Project Title:
CHAPELTON OF ELSICK FRA

CHAPELTON OF ELSICK PHASE 1a
FLOOD RISK ASSESSMENT

Planning Application: APP/2011/3103

**Full Planning Permission for Phase 1A of New Settlement, Comprising 802
Dwellinghouses, Retail and Commercial Floorspace, Civic Buildings and
Associated Landscaping at Land to West of Chapelton of Elsie, Newtonhill,
Stonehaven**

Drawing Title:
EXTENT OF FLOODING
PHEPPIE BURN
PHASE 1A

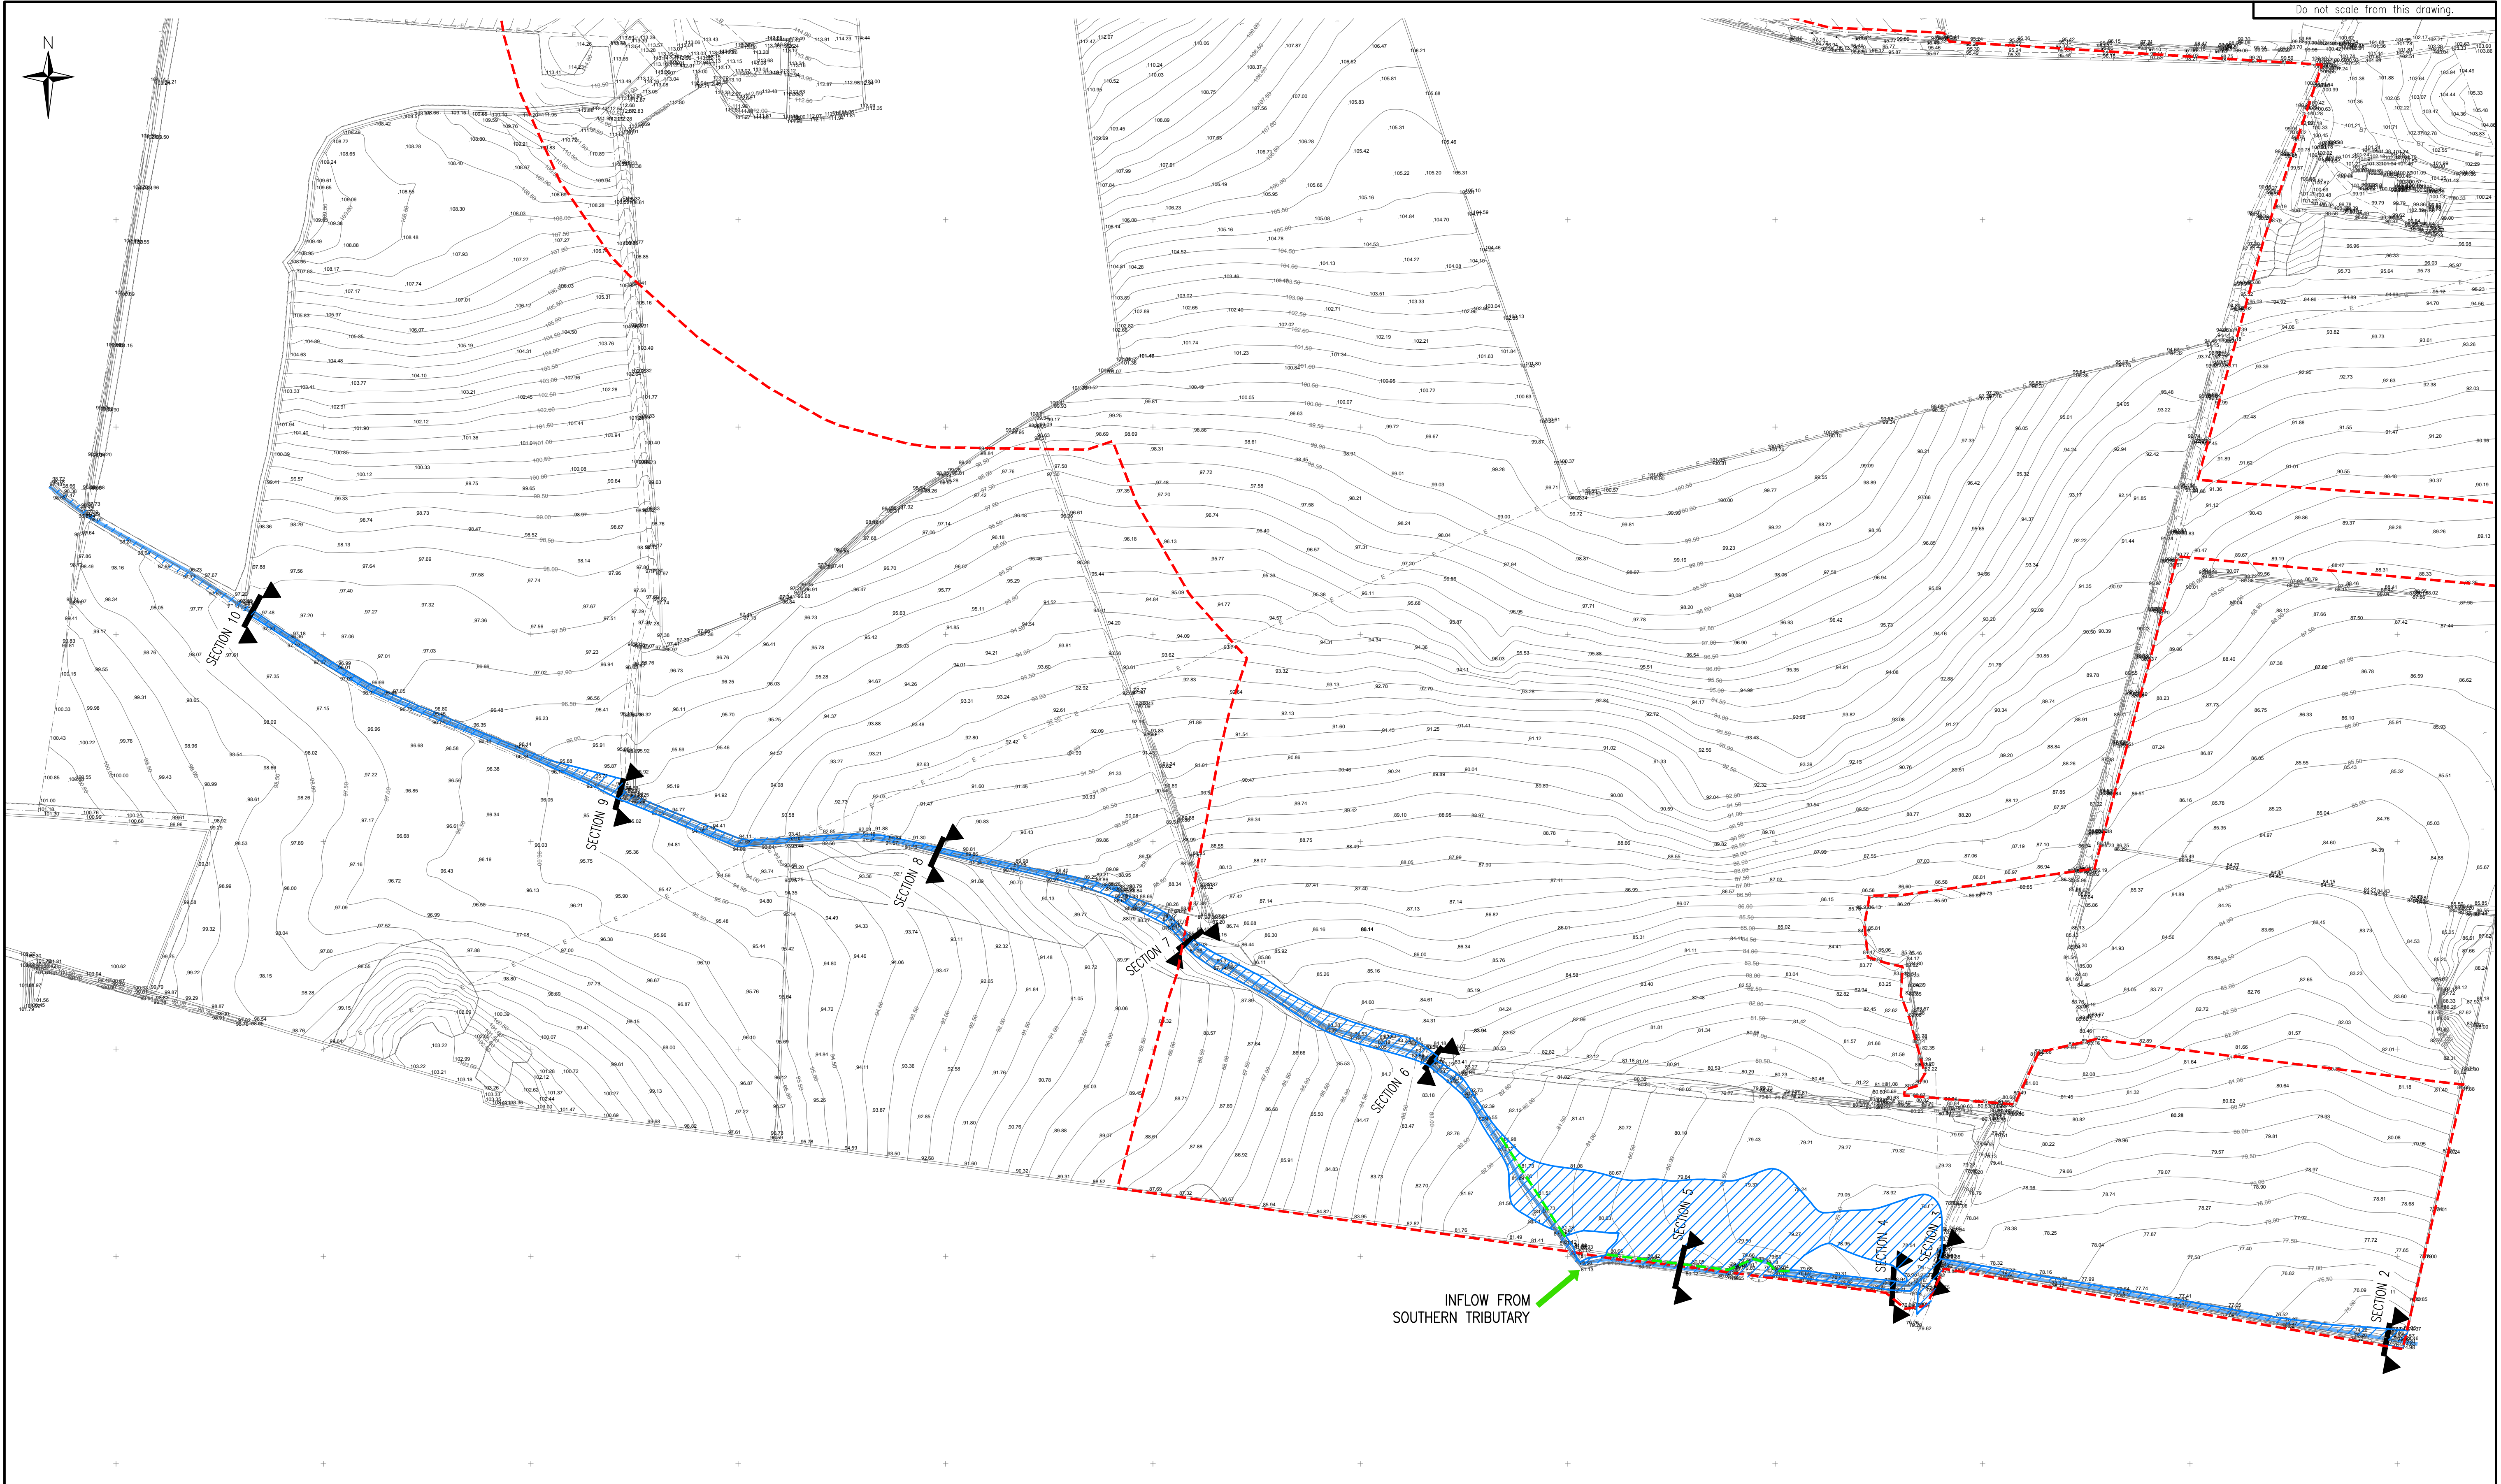
- 1.2 The FRA submitted for Phase 1A is based on the assessment of flood risk carried out for the master plan and does not take the hydraulic capacity of the crossing on the Pheppie Burn into consideration. It depicts flooding from the Burn of Pheppie affecting mostly open ground but some properties and parts of access routes near the crossing may be at risk of flooding.

- 1.3 Therefore, based on the information provided, we consider that a detailed FRA has not been submitted in support of the Phase 1A proposal. We **object** to this application due to lack of information on flood risk grounds. In order to remove this objection a detailed FRA should be undertaken to accurately determine the 200 year flood envelope and therefore the associated developable area.

- 1.6 We welcome that the majority of the development has been designed to be located outwith the areas at significant risk of flooding. However, there are at least two buildings in Block 5 which are still with an area identified at risk of overland flow from out of bank flows of the Pheppie Burn. This area is still within an area identified at significant risk of flooding and **we require them to be removed or relocated on an amended the plan.** It is also noted that in section 6.2 that there is predicted to be out of bank flow from the northern tributary in the area of lower Nether Cairnhill field to the east. “Flow water would flow overland before returning to the watercourse via the Pheppie Burn floodplain in the south east corner of the field. It is unclear where this is on any current plan or if any development is proposed at this location. As such further clarification should be provided with regards to this and we would re-iterate that the avoidance approach should be a key design principle particularly given the significant masterplan area available outwith an area at significant risk of fluvial flooding.

- Details to confirm that any new or proposed upgrades to watercourse crossings can convey a 1 in 200 year flow.
 - Details of where overland flow occurs both on the Pheppie Burn and the Northern Tributary indicating on relevant plans that proposed buildings are removed or relocated outwith these areas (for example revision of two buildings proposed in block 5 currently indicated within the Pheppie Burn overland flow area).

- The modelled design flood levels and layout plans and finished floor levels should reflect an allowance for climate change.
 - Modification of the site layout plan to remove all buildings out of the 1:200 flood extent.
